Sundry Print Report

Well Name: OUTRIDER 27 FED	**Well Location:** T24S / R32E / SEC 28 / SWSE /	**County or Parish/State:** /
Well Number: 511H	**Type of Well:** OIL WELL	**Allottee or Tribe Name:**
Lease Number: NMNM016353	**Unit or CA Name:**	**Unit or CA Number:**
US Well Number: 3002550235	**Well Status:** Drilling Well	**Operator:** XTO ENERGY INCORPORATED

Notice of Intent

Type of Action: APD Change

DRAWN	DLE	15SEP22
APPRV		
DRAWING NO.	SDT-3747

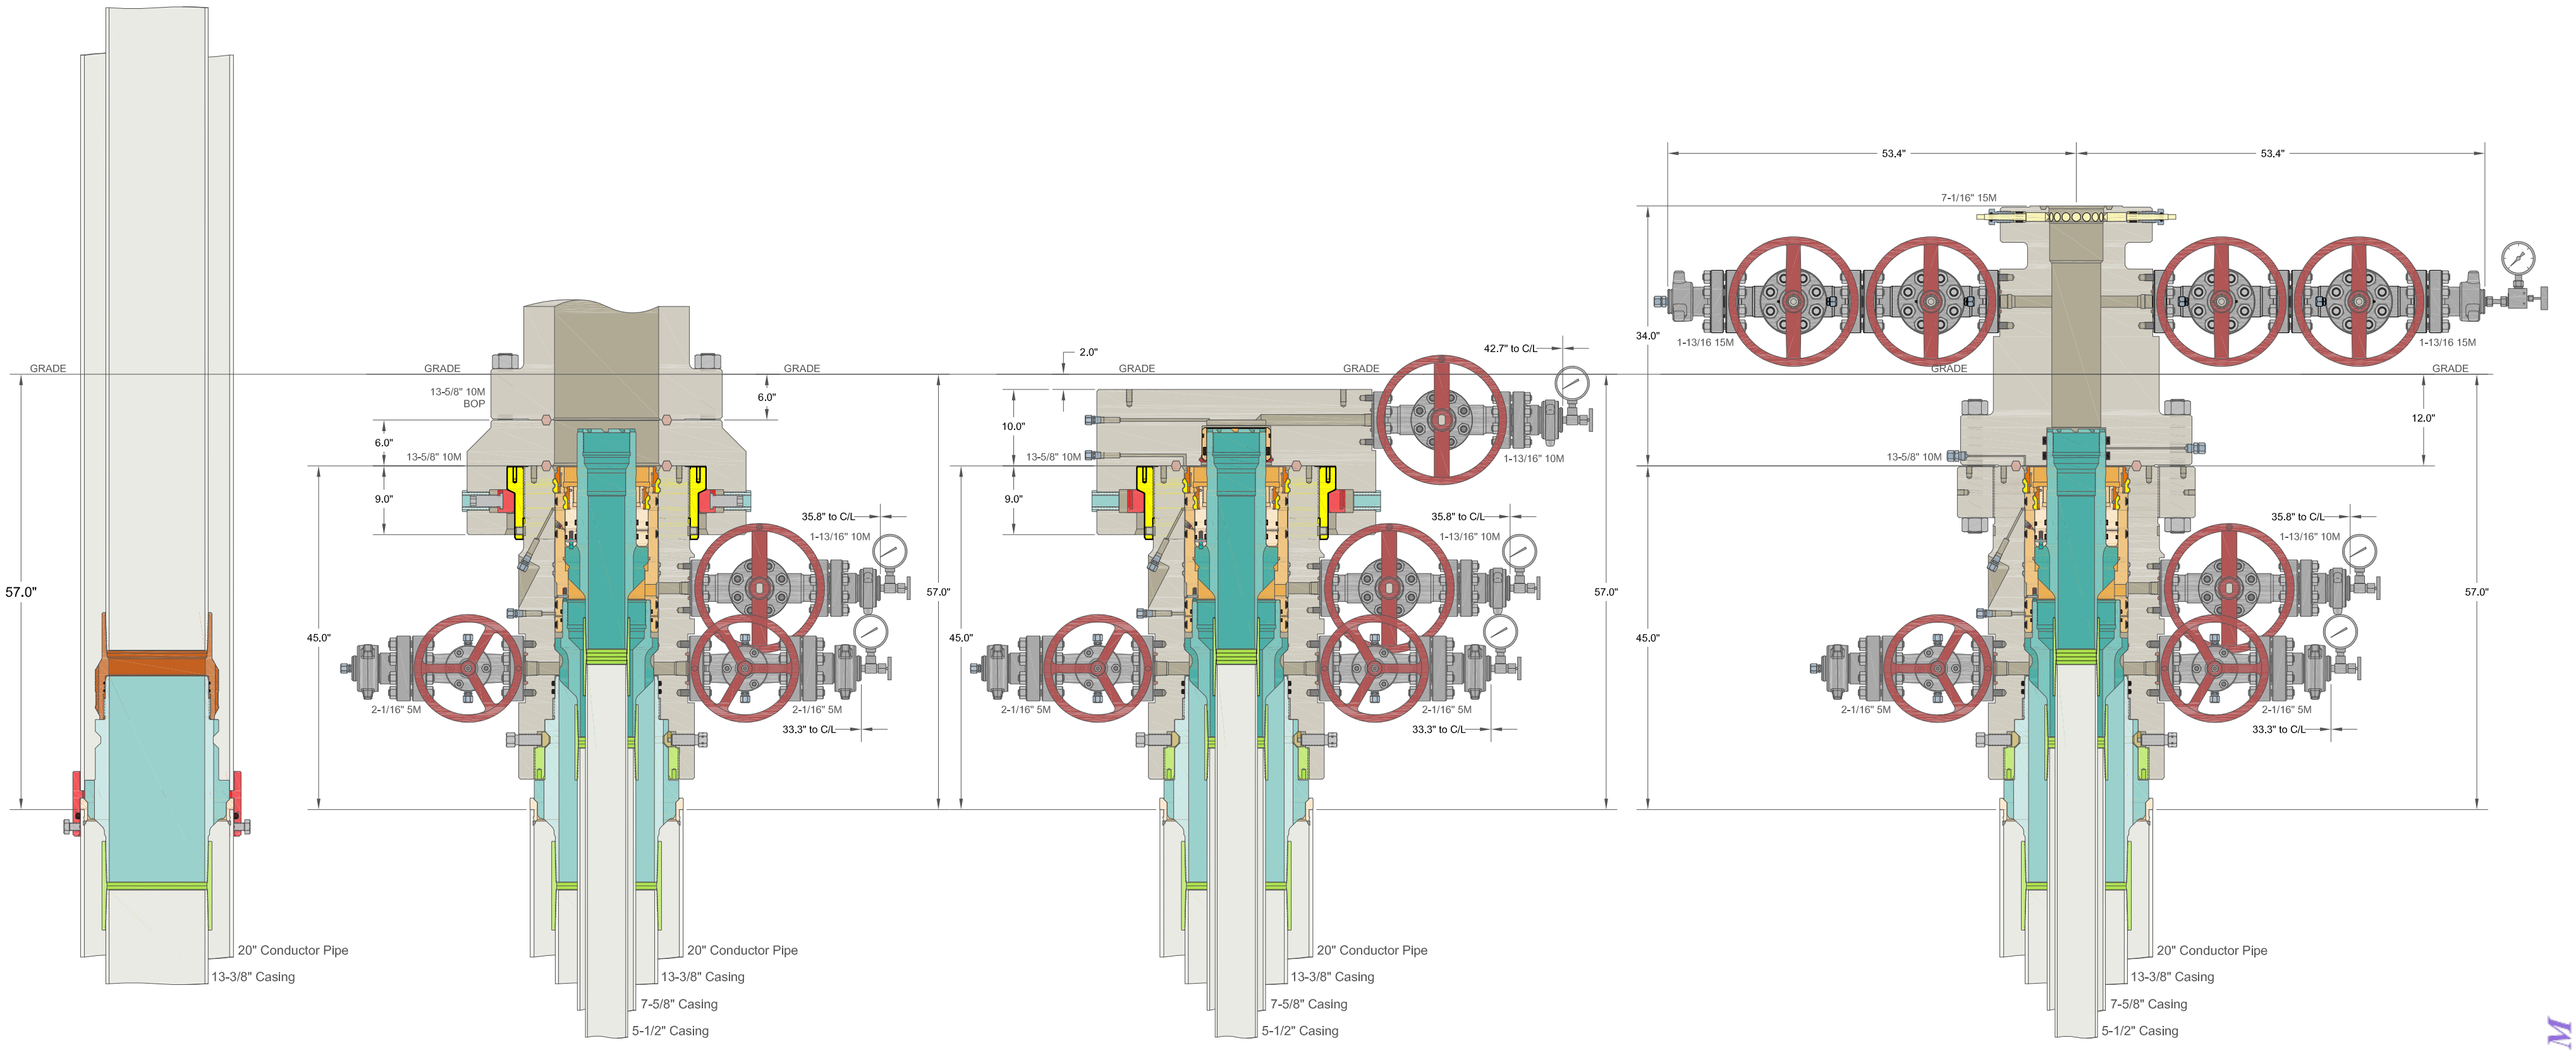
Procedure Description: XTO Energy Inc. requests permission to make the following changes to the original APD: Intermediate Hole, Casing, and Cement to – 8.75” hole, 7.625” HC L-80 29.7# Csg set fr/0-11700’ with 1620sx Class C Cement Production Hole, Casing, and Cement to – 6.75”hole, 5.5” RY P-110 20# Csg set fr/0-17899’ with 30sx NeoCem (Lead) and 400sx VersaCem (Tail) XTO also requests update to the multibowl system/wellhead configuration. See diagram attached. Attachments: Drilling Program MBS

2. Operator has proposed a multi-bowl wellhead assembly. This assembly will only be tested when installed on the surface casing. Minimum working pressure of the blowout preventer (BOP) and related equipment (BOPE) required for drilling below the surface casing shoe shall be **5000 (5M)** psi.

a. Wellhead shall be installed by manufacturer’s representatives, submit documentation with subsequent sundry.
   b. If the welding is performed by a third party, the manufacturer’s representative shall monitor the temperature to verify that it does not exceed the maximum temperature of the seal.
   c. Manufacturer representative shall install the test plug for the initial BOP test.
